UNITED STATES PATENT AND TRADEMARK OFFICE

Office Action Summary

10/670,566

DETAILED ACTION

(Please refer to figure 1 below for further clarification)

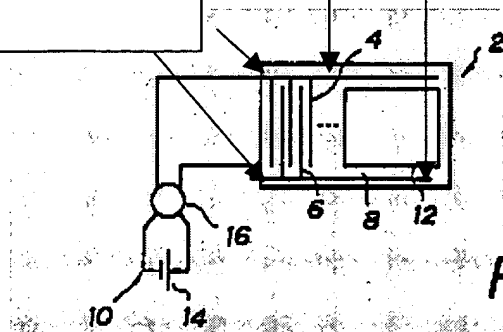
Kasahara teaches an insulating layer (22), a plurality of electrodes arranged alternately with positive and negative with respect to an insulating layer (4,6 and Figure 2) and a plurality of feeding terminals each of the feeding terminals connected with each of the electrodes and disposed on the side of one of longitudinal edges of a belt, wherein feeding terminals for feeding positive voltage exposed outside of the side of one of a surface or a back of a belt and feeding terminals for feeding negative voltage extending towards the other of a surface or a back of a belt (Column 6, Lines 46-57 and Figures 1,3,4).

In figure 1, the feeding terminals (power source 14) are disposed on the side of a longitudinal edge of belt (denoted by arrows) wherein the feeding terminals are exposed outside of the side of one of a surface (denoted by arrows).

Arrows denotes terminals extending towards the back of belt.

8. Applicant's arguments filed 9/28/04 have been fully considered but they are not persuasive. In response to applicant's remarks regarding claim 22, the examiner consider the amended features of the claim, however the action remains rejected over Kasahara '461. The terminals from power source (14) are exposed outside on the side of one of surface or of a back side of a belt (please refer to rejection of claim 22 in disclosed office action).
